Access Compliance Report

Public Rights-of-Way

(Curb Ramps)

Intersection ID: 3038	Main Street: FAWNDALE_DR	Cross Street: WHITE_STAG_DR	Location: E
ADA ID: B06B10D6A1C9	Ramp Type: Perp	Initial Pass/Fail: Pass	Overall Compliance: No
		Severity Score: 11.5

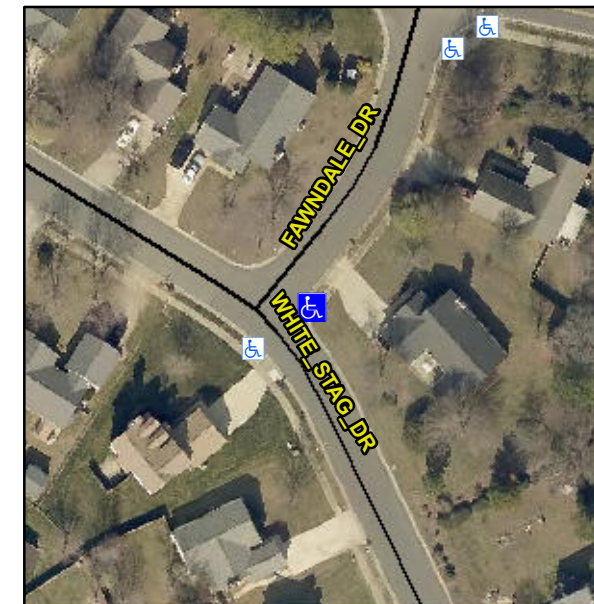
**Not Found, R304.5.1, R304.5.3,
R304.2.3, R305.1.4, R305.2, R304.5.4**

Compliance	Description	Data	Compliance	Description	Data
N/A	Ramp Length (in)	46.0	Yes	Ramp Slope (%)	5.8
No	Ramp Width (in)	47.5	Yes	Ramp XSlope (%)	3.9
N/A	Flare Type LT	Sloped	N/A	Flare Type RT	N/A
N/A	Flare Slope LT (%)	4.9	No	Flare Slope RT (%)	11.9
N/A	Flare Traversable LT?	Yes	N/A	Flare Traversable RT?	Yes
Yes	Landing Length (in)	48.0	Yes	DWS Provided?	Yes
Yes	Landing Width (in)	48.0	Yes	DWS Contrast?	Yes
Yes	Landing Slope (%)	0.4	Yes	DWS Length (in)	25.5
No	Landing X Slope (%)	4.6	No	DWS Full Width?	No
N/A	Landing Curb? (Y/N)	No	No	DWS Offset (in)	3.0
N/A	Shared Landing?	No			
Yes	Gutter Ponding?	No	No	Gutter Slope (%)	5.9
Yes	Gutter Lip Ht (in)	0.0	No	Gutter X Slope (%)	4.7
N/A	Painted X Walk1?	No	N/A	Painted X Walk2?	N/A
	X Walk 1 Direction	To SW		X Walk 2 Direction	N/A
N/A	X Walk 1 Width (in)	N/A	N/A	X Walk 2 Width (in)	N/A
	X Walk 1 Slope (%)	3.6		X Walk 2 Slope (%)	N/A
	X Walk 1 X Slope (%)	3.9		X Walk 2 X Slope (%)	N/A

**Remove & Replace Entire Ramp.
Remove & Replace Gutter.**
